Robert Bowen Planning and Development Ltd

FCA/ Flood Management Plan

**Salem Chapel Brynawel Crynant Neath Port Talbot
SA10 8SR**

Change of use to residential care home (Class C2)

Figure 2

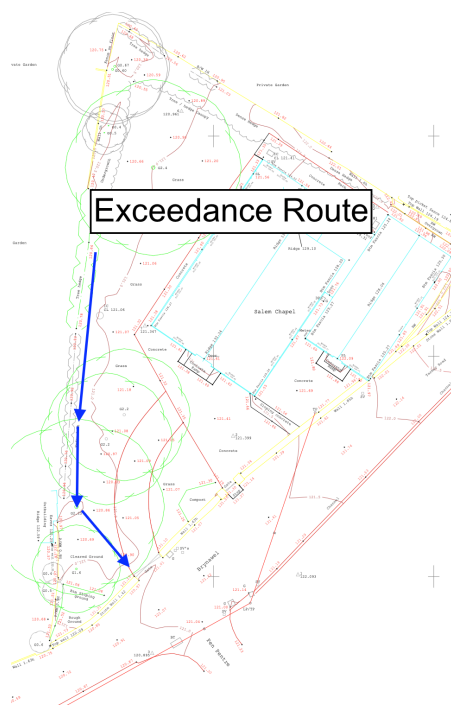
LLFA Comments	Reply
<i>No topographical/ exceedance plan has been provided to demonstrate site levels, identify overland flow routes, and show how surface water will be managed without increasing flood risk elsewhere. This information may be contained within drawing 982b-LvWH-GEM-BC-DR-GEN-1010 Rev B, however this drawing has not been submitted.</i>	Topographical survey with exceedance routes provided. 25.297.02 TOPO & 25.297.02. Exceedance Route Plan 982b-LvWH-GEM-BC-DR-GEN-1010 Rev B was submitted and is available on the LPA portal.
<i>No statement has been provided on historical flooding at the site. If there are no known incidents, a brief statement confirming this should be provided. We don't have any records of flooding at this location.</i>	See paragraph 2.2
<i>Permeable paving is proposed as part of the development; however, there is a lack of site information provided to justify its suitability. The application is missing detailed drawings, calculations, and evidence of ground suitability (if infiltration is proposed).</i>	Permeable paving is proposed to protect adjacent trees, assist in surface water control and to provide a more attractive finish. The applicant is prepared to use other materials. Matters in relation to infiltration and detailed design can be dealt with by a suitably worded condition attached to the planning permission.

- 2.5 NRW flood maps indicate a small section of surface water flooding on the western boundary. **Figure 1** The submitted plans (*982b-LvWH-GEM-BC-DR-GEN-1010 Rev B and Topographic survey 25.297.03 May 2025*) indicate that the site levels in this area are typically less than 120.85m AOD. The site rises towards the chapel to the east (FL 121.61m AOD) and falls south toward the highway (120.69m – 121.1m AOD). Exceedance routes will therefore flow south away from the building and towards the southern boundary. **Figure 2**

Figure 4

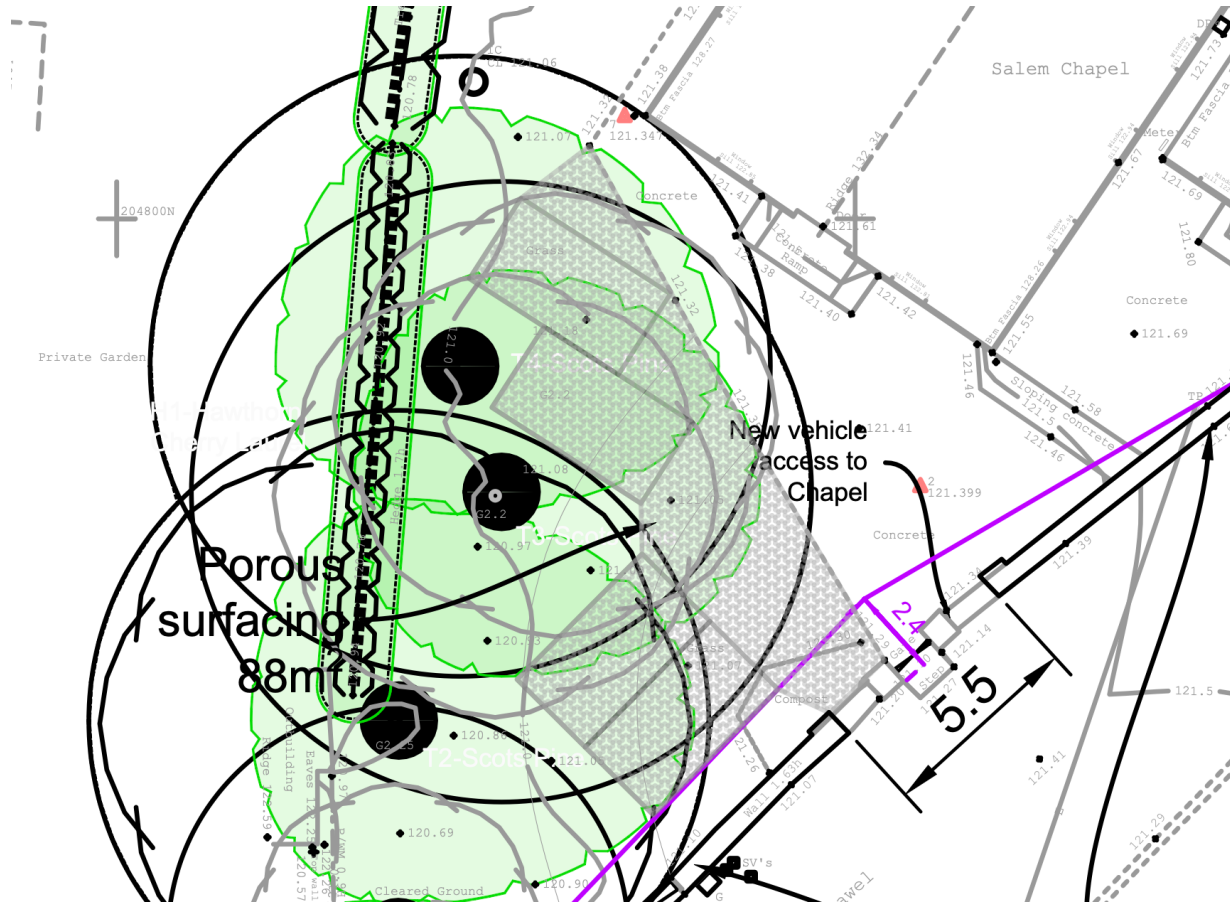
Please confirm the future maintenance arrangements for the permeable paving within the site.

These matters can be dealt with by a suitably worded condition attached to the planning permission.
